Product Change Notice (PCN)

PCN Number: **PCN-021028R-01**

Product(s) Affected: **SIM-2-A**

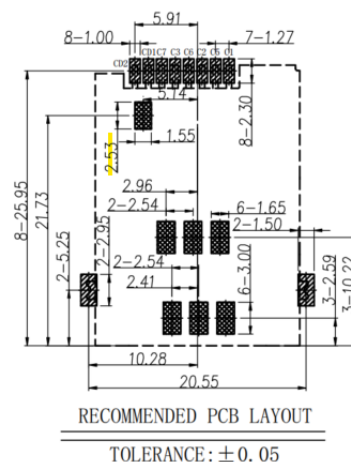
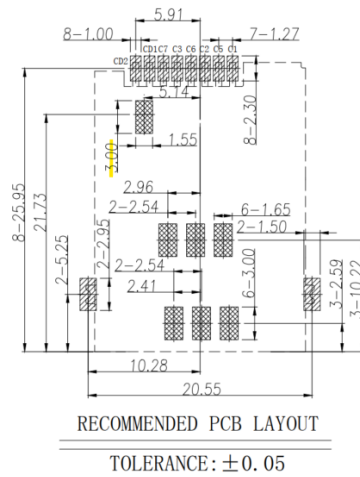
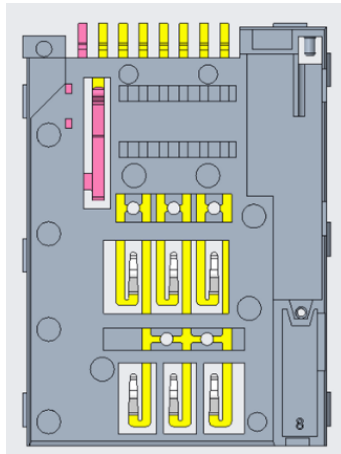
Reason(s) for Change: *Product mold is aging and soon requires replacement. The new replacement mold will contain small design improvements made to the card detection pin.*

Description of Change: *Mold Replacement. Design improvement. The card detection pin will be moved to be directly molded onto the plastic body of the card connector for a flatter and more secure connection. The card detection pin change has also resulted in a small change in the PCB footprint.*
